## **Record of Revisions – Revision 13 (December 2021 with June & July 2022 change pages)**

### **Official approval of Versa-Pac SAR Revision 13 June and July 2022 change pages: DCN-22-003**

**Figure 3-27 VP-55 1S/2S UF6 Cylinders – Containment Inner Surface Temp. with Foam Liners**

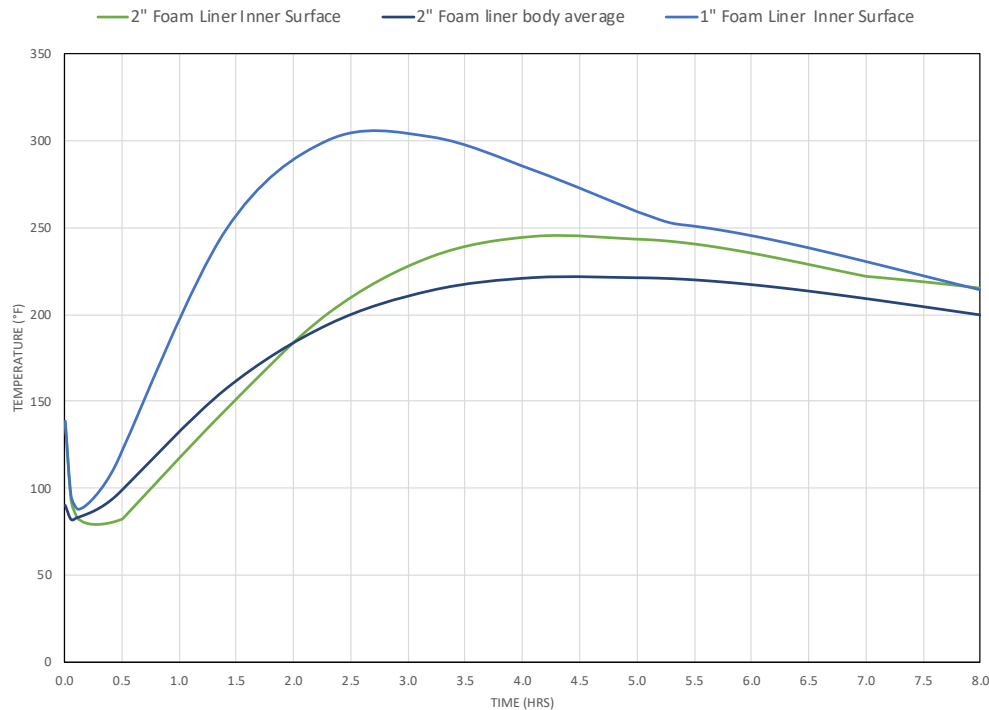
- Section 3.5.1 changed Reference [2] to “Latest Revision” and added References [17] through [19]
- §3.5.2 year ‘2012’ removed from ANSI N14.1 reference.
- Table 3-18 Changed containment gasket maximum allowable temperature to 500°F.
- Table 3-21 Changed containment gasket maximum allowable temperature to 500°F.
- §3.5.4 added appendix for HCB thermal analysis.
- §3.5.5.2.1 updated table numbering due to added HCB appendix.
